A47 Blofield to North Burlingham

Volume 8
8.13 Statement of Common Ground
with National Highways
and Blofield Parish Council

Statement of Common Ground – Blofield Parish Council

STATEMENT OF COMMON GROUND

1. Highways England a. Cucumber Lane Roundabout

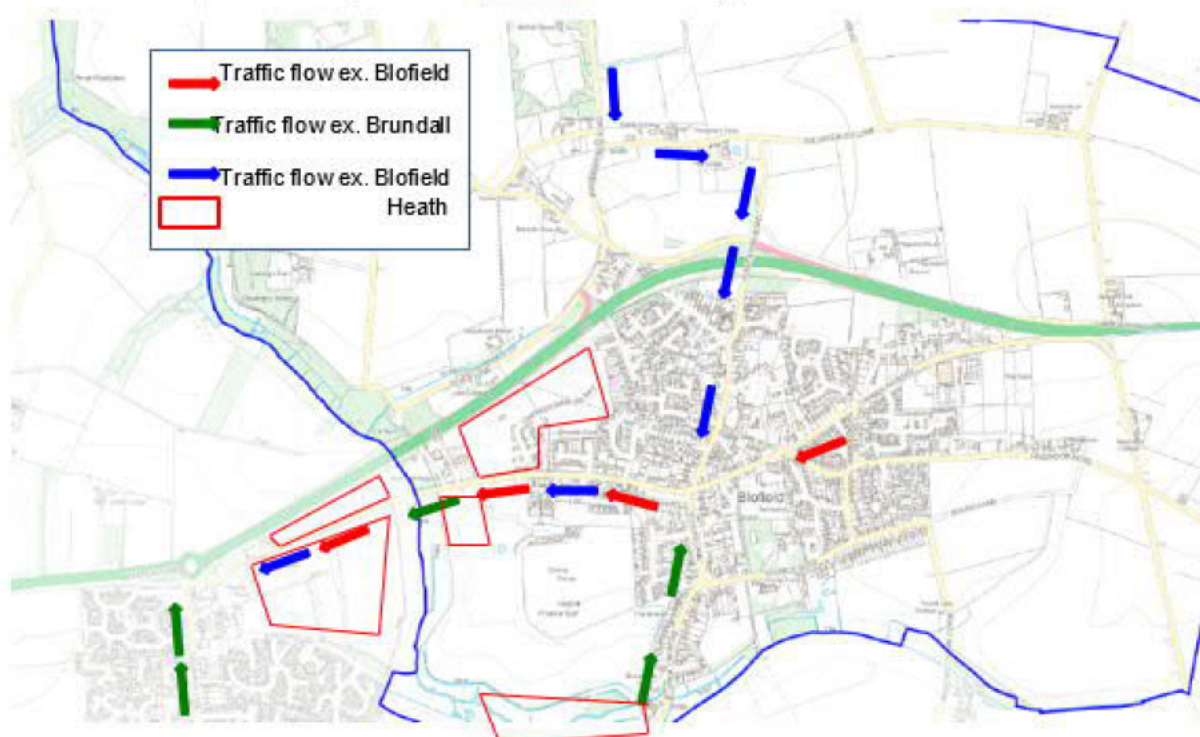
With increased existing and approved residential developments in the villages of Blofield, Blofield Heath and Brundall increased pressure on the village infrastructure continues to mount. Access West towards Norwich from these villages relies, in the main, on access to the A47 dual carriageway at the roundabout at the Cucumber Lane (from Brundall) / Yarmouth Road (from Blofield) junction.

Traffic routes (as indicated on the map) show traffic emanating from Blofield Heath, Brundall and Blofield itself all concentrating on this junction. Already traffic on the A47 approaching from the East (Acle / Gt. Yarmouth) approaches the junction at high speed and volume causing congesting at the roundabout for traffic joining from the villages, causing tailbacks at peak times.

b. Traffic flow through the village

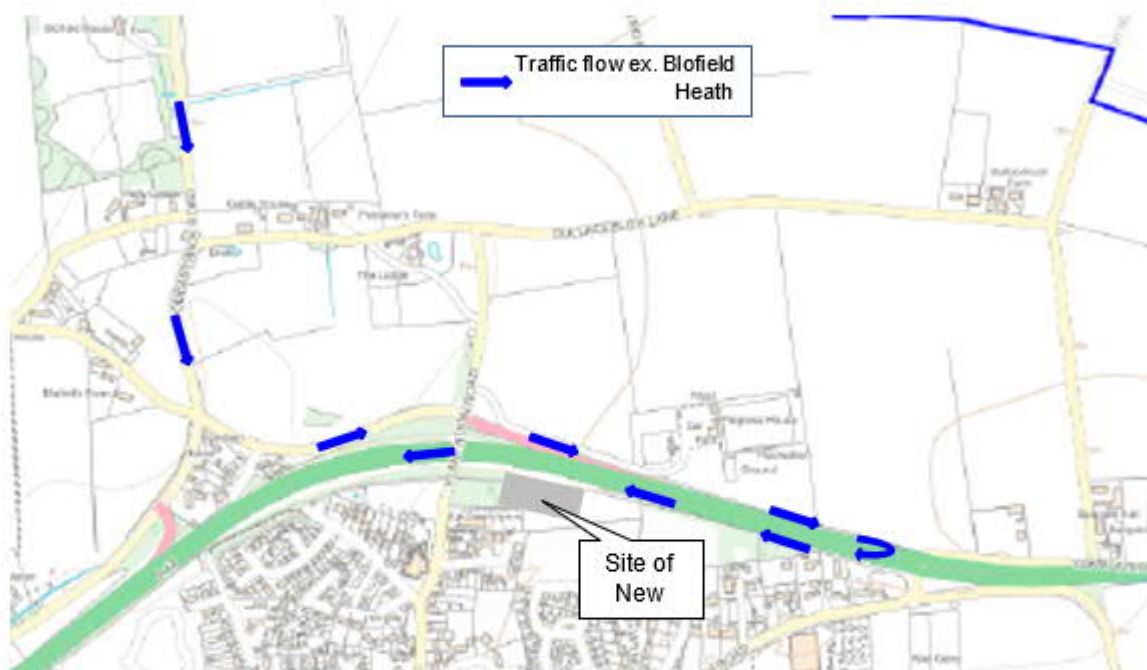
During Consultation with Highways England on the proposed plans for dualling from Blofield to North Burlingham it became apparent that a reasonable number of Blofield Heath residents were travelling south out of their village towards Blofield, using the slip road to join the A47 East towards Acle and using the gap in the central reservation (access to east end of Blofield) to execute a U-turn at this junction to join the A47 WEST towards Norwich.

As part of the dualling scheme Highways England plan to close this break in the central reservation therefore closing off this access route towards Norwich. The consequence of this is to force all of the traffic from Blofield Heath through the already congested village of Blofield and along Yarmouth Road to the Cucumber lane roundabout (see 1a above).

Norfolk County Council also plan to build a new primary school in the next 2-3 years at the location shown on the map that is at least DOUBLE the size of the existing school thus creating even more traffic along a typical village road. As NCC had, at the point of the consultation with Highways England, not yet submitted planning applications, HE were unaware of this until advised by the Parish Council. They committed to consider this in their planning.

Figure 2

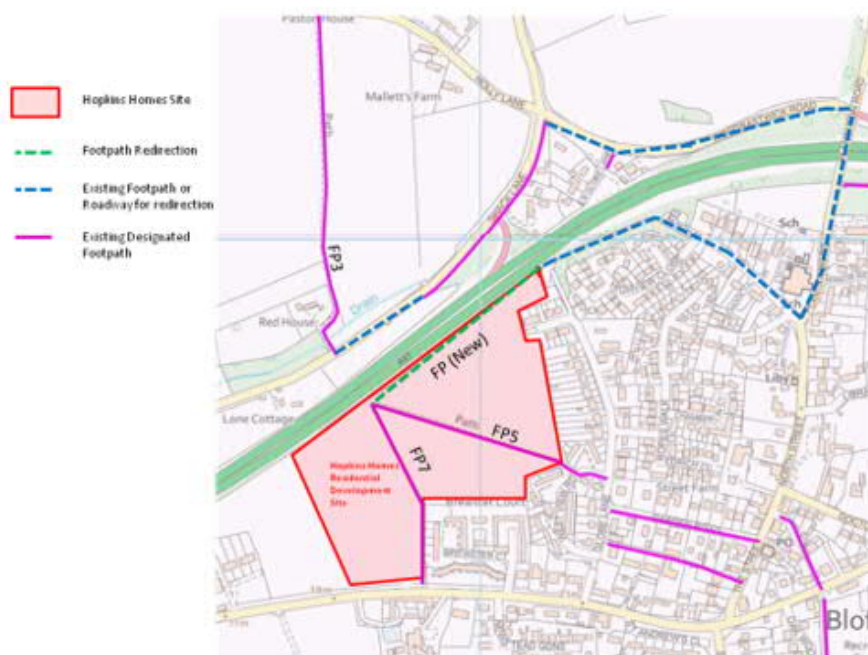
As a consequence of the above the Council is proposing to seek redirection of the footpath as outlined in Figure 2 below.

Due to limited crossing points of the A47 the redirection would be as follows :

- Establishment of new recognised footpath along the Northern Boundary going north-east to join existing footpath to North Street.
- South-east along pavement to Plantation Road
- North along Plantation Road, crossing A47 over roadway bridge
- West on Woodbastwick Road
- South-west on Shack Lane to rejoin FP3 at existing point

2.3 Works Plans

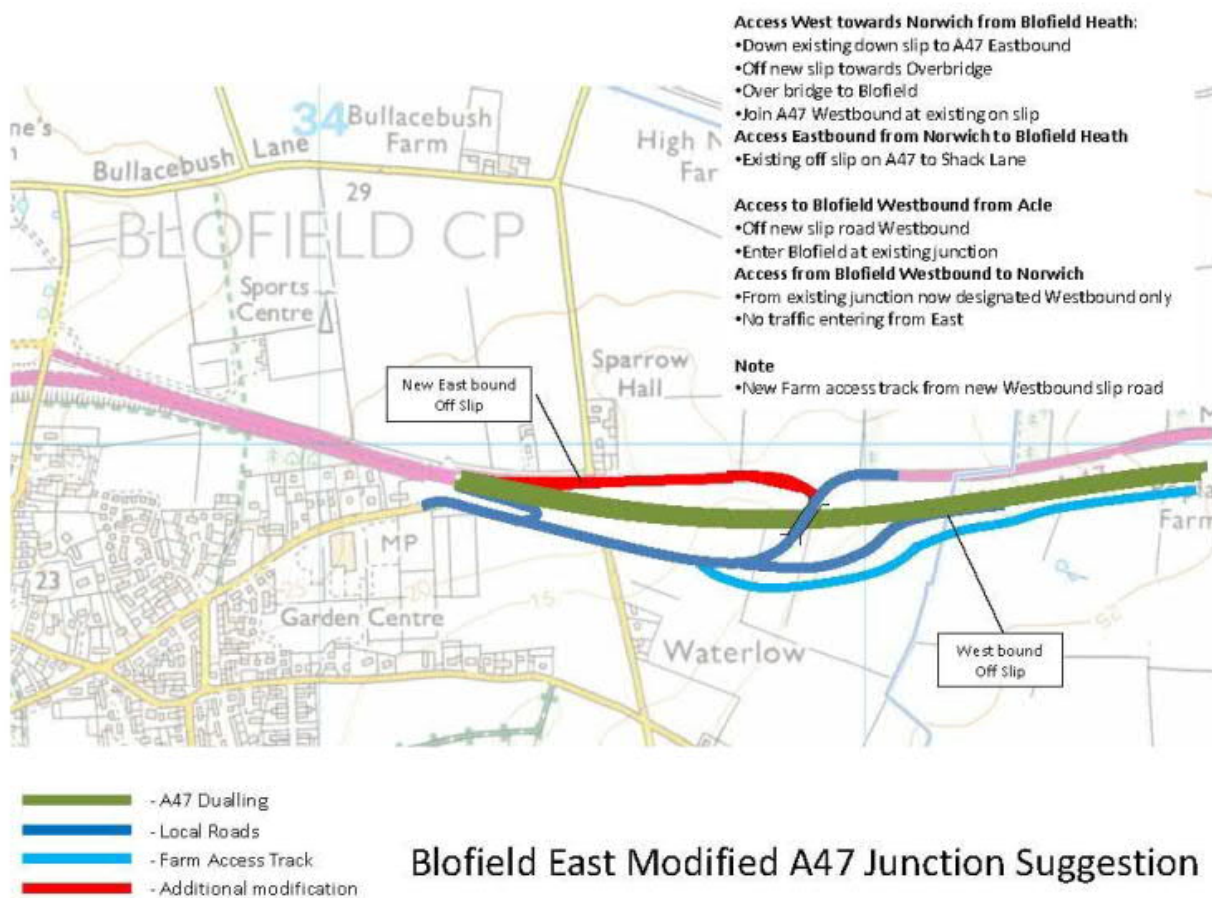
Blofield Parish Council is disappointed that the suggested alternative junction layout has been completely disregarded by Highways England.

This was proposed to Highways England due to the following concerns which have been ignored.

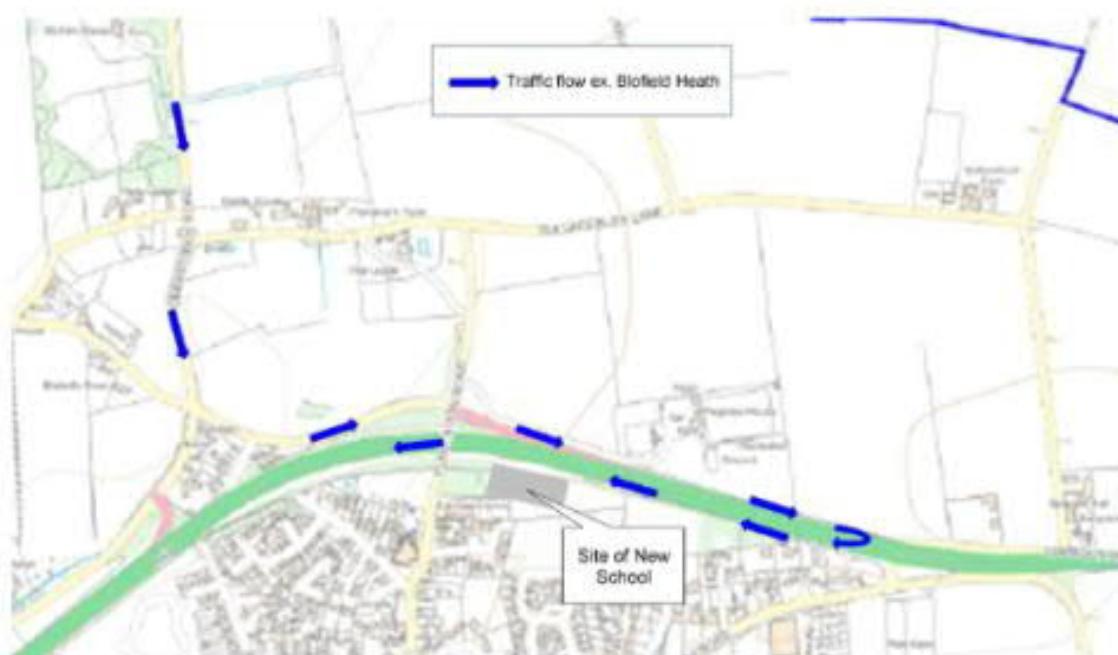
Traffic flow from Blofield Heath suggests that a high number of parishioners are exiting Blofield Heath, travelling south towards Blofield, using the slip road to join the A47 East towards Acle and then using the gap in the central reservation to execute a U turn to then travel to towards Norwich on the westbound A47, as indicated below.

As the proposal for the A47 junction will close off the gap in the central reservation, it is our view that traffic will be forced to enter Blofield and encounter the already congested road network in the vicinity of the current school site, doctors surgery and proposed new school site for onward travel to the A47 Cucumber Lane roundabout for onward travel to Norwich.

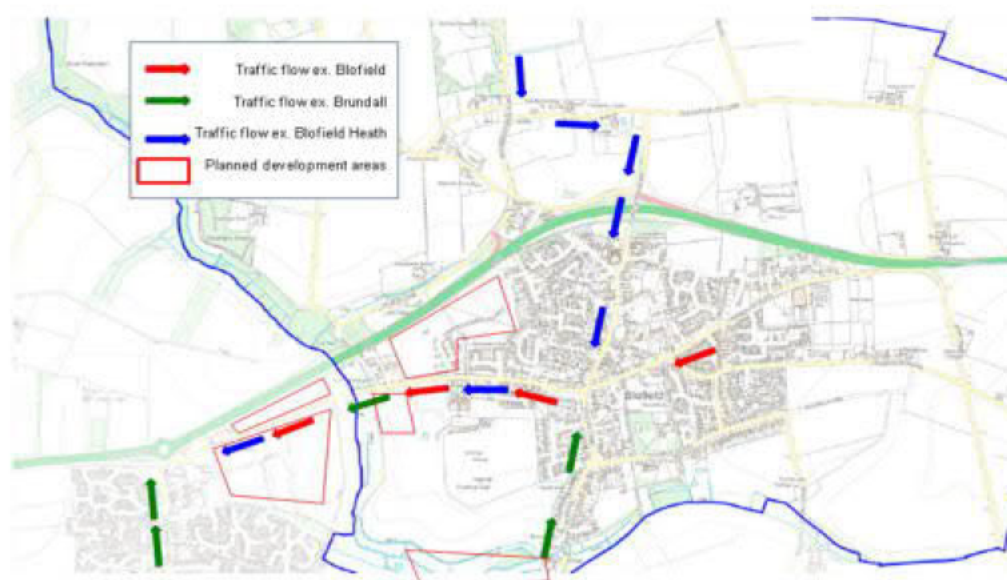
Page 3 : Cucumber Lane Roundabout: Therefore, the implementation of the Scheme is not the underlying reason for the capacity related operational issues at the junction. **It may not be the underlying reason but shouldn't a scheme also try to resolve a recognised problem**

With increased existing and approved residential developments in the villages of Blofield, Blofield Heath and Brundall increased pressure on the village infrastructure continues to mount. Access West towards Norwich from these villages relies, in the main, on access to the A47 dual carriageway at the roundabout at the Cucumber Lane (from Brundall) / Yarmouth Road (from Blofield) junction.

Traffic routes (as indicated on the map) show traffic emanating from Blofield Heath, Brundall and Blofield itself all concentrating on this junction. Already traffic on the A47 approaching from the East (Acle / Gt. Yarmouth) approaches the junction at high speed and volume causing congesting at the roundabout for traffic joining from the villages, causing tailbacks at peak times.

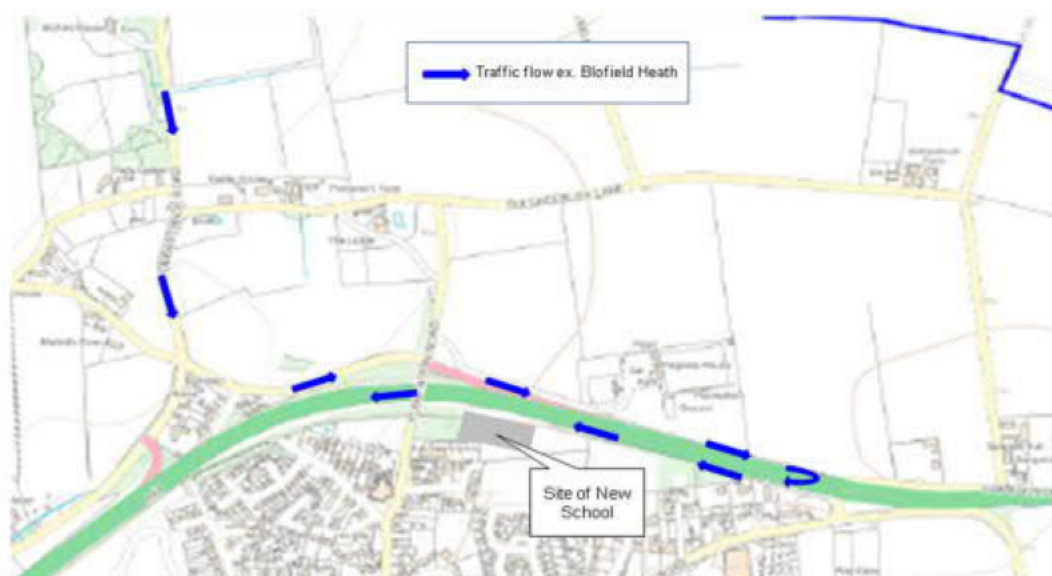
Page 5: As the proposal for the A47 junction will close off the gap in the central reservation..... traffic will be forced to enter Blofield and encounter the already congested road network in the vicinity of the current school site, Drs Surgery and the proposed new school site for onward travel to Norwich. **This has missed the point of bringing extra traffic onto The Street and the new enlarged school which has not been taken into consideration. It is not just to do with Cucumber Lane Roundabout. We are aware that the cucumber lane roundabout is outside the development boundary for this scheme.**

During Consultation with Highways England on the proposed plans for dualling from Blofield to North Burlingham it became apparent that a reasonable number of Blofield Heath residents were travelling south out of their village towards Blofield, using the slip road to join the A47 East towards Acle and using the gap in the central reservation (access to east end of Blofield) to execute a U-turn at this junction to join the A47 WEST towards Norwich.

As part of the dualling scheme Highways England plan to close this break in the central reservation therefore closing off this access route towards Norwich. The consequence of this is to force all of the traffic from Blofield Heath through the already congested village of Blofield and along Yarmouth Road to the Cucumbers lane roundabout (see 1a above).

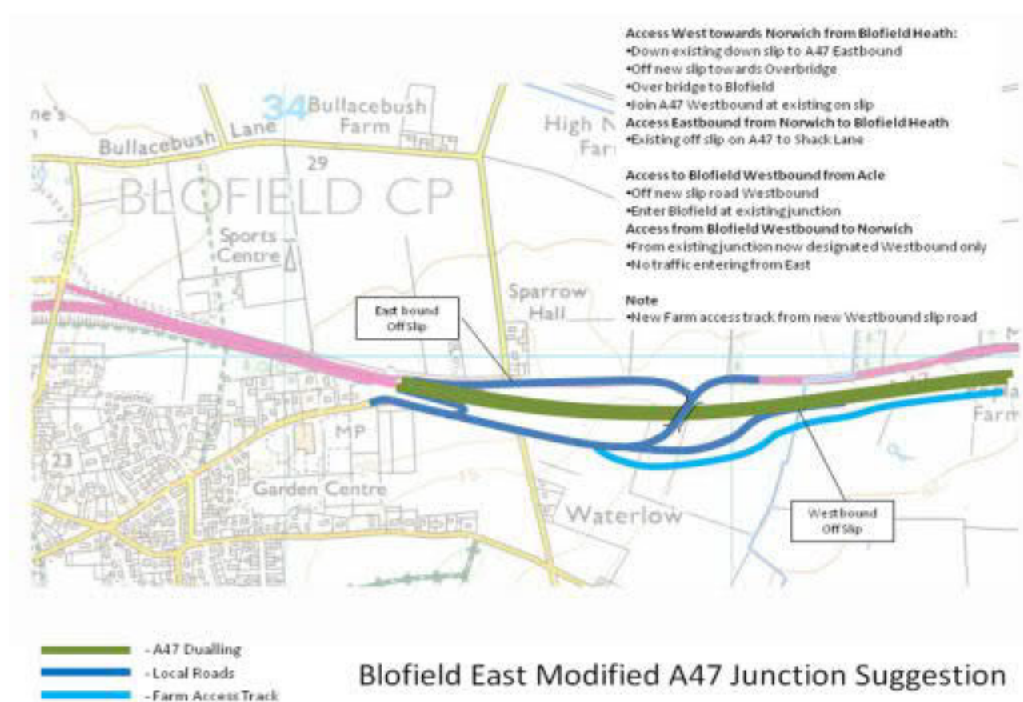
Page 7: Yarmouth Road Junction It is still disappointing that the alternative option has been discounted with no discussion with anyone with local knowledge. We will probably have to “agree to disagree”.

Following the meeting Blofield Parish Council proposed the alternate junction (see below) at the eastern end of Blofield that would potential alleviate both of the issues above.

This was submitted to Highways England for consideration (as it was felt only minor changes were required) but has been completely ignored and discounted in the final plans and submission of the DCO.
